Mansfield Township Wastewater Management Plan
Margolis Warehouse Distribution Facility
Lots 3.02, 9.01, 9.02, 11 and 12
Mansfield Township, Burlington County, NJ

Figure 2 – Proposed warehouse development

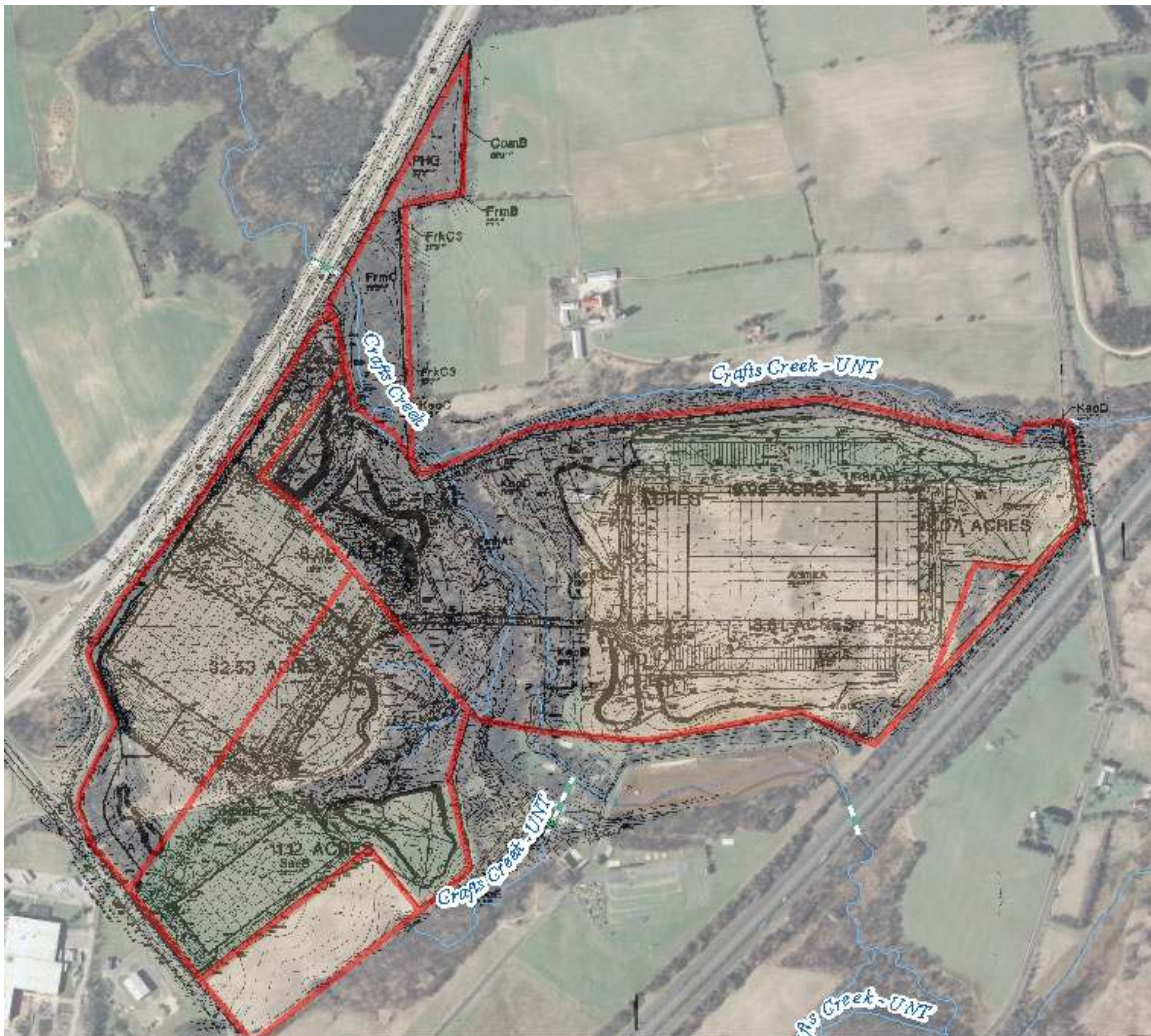
The impacts of the proposed grading and construction do not seem to have been considered in the design of the groundwater discharges. Building 1 is proposed to the SE

of the disposal field and proposes an infiltration structure at the base of the building facing the disposal field. Building 2 is proposed to the NE of the disposal field and proposes to excavate up to 12 feet of the existing ground to provide a level area for the building to be constructed, which is almost to the depth of the test pits in the area so no soil information below the proposed grade is really available, and an approximate 10 foot high slope will be created within 80 feet of the NE side of the disposal field is being created. The building layout effectively funnels all groundwater flow toward the existing gully on site. It will be necessary to provide an analysis to show that there is sufficient area to treat the expected flow, that there will be no seepage along the slope created for the construction of building 2, that groundwater flow from the septic area will not be intercepted or cause a mounding condition in the proposed infiltration structure, proposed along Building 1, or create a “piping” situation along the stormwater line discharging into detention basin no. 8.

Looking at the proposed site plan there is no evidence of any non-structural measures being incorporated into the design. The site plan appears to have maximized the development on all buildable areas of the site with extensive regrading and a complete change to the drainage patterns. Instead of a disconnected system with vegetated open channels mimicking the existing drainage patterns, the proposed system provides a directly connected system from the roofs and other impervious surfaces to the stream channel, with a net loss of 12.1 acres of wooded area and 0.4 acres of wetlands.

3. In the post construction condition, 34.6 acres are described as being “Unconnected Impervious with Large D/S Pervious”. A review of the site plan indicates that all stormwater discharge is through pipes in a concentrated flow into the stream channel or existing drainage paths and not onto pervious surfaces in a sheetflow condition. This credit appears to have been taken because the spreadsheet instructions allow roof runoff directed to a dry well to be considered as such. Normally a dry well will infiltrate the design storm under a lawn area and if it fails the resultant overflow will pass over a lawn area essentially acting in

4. According to the spreadsheet the project is creating 63.4 acres of lawn/open space. A review of the plans indicates that the proposed detention basins account for the majority of this area, approximately 50 acres. The instructions for the NSPS spreadsheet directs the user to code structural measures in the post development condition as the predominant land use in the structure. However, the extensive regrading on the site and the extent of the concrete low flow structures precludes these basins from acting in a “natural” fashion as envisioned by the instructions.

- 1) Instead of the standard practice of assessing the flow reductions at the end of the pipe before the flow enters the stream, this project proposes to assess the reductions in stream close to the downstream end of the property. The instream flow portion of the routing is oversimplified in that it is just assuming a 4 fps velocity in the stream based on the HEC-RAS model and is just adding the outflow hydrographs shifted by the assumed travel time. This methodology ignores the stream conditions (obstructions), the existing flow in the channel and flow coming into the channel from the tributary north of the Eastern side of the property, all of which will influence the travel time in the channel and affect the peak flow. For example the flowpath in the channel is measured along the low flow channel, however, in reality when this flow enters the valley, flow will most likely be out of bank and follow a straighter and faster path than the calculations assume. To correctly evaluate the combined flows in the stream it will be required to perform a detailed routing including all flows and modeling the obstructions in the channel, or that the outfalls for basins 8 and 9 are located in a drainage ditch from the farm fields yet the velocity from the stream channel.

- 8) In the Pond Pack Model for the proposed condition, the model has the flows from Basins 2 and 3 meeting at Junction 2 in the stream. According to the site plan Basin 3 discharges into the outfall pipes from Basin 2 approximately 580 ft above the outfall (junction 2).
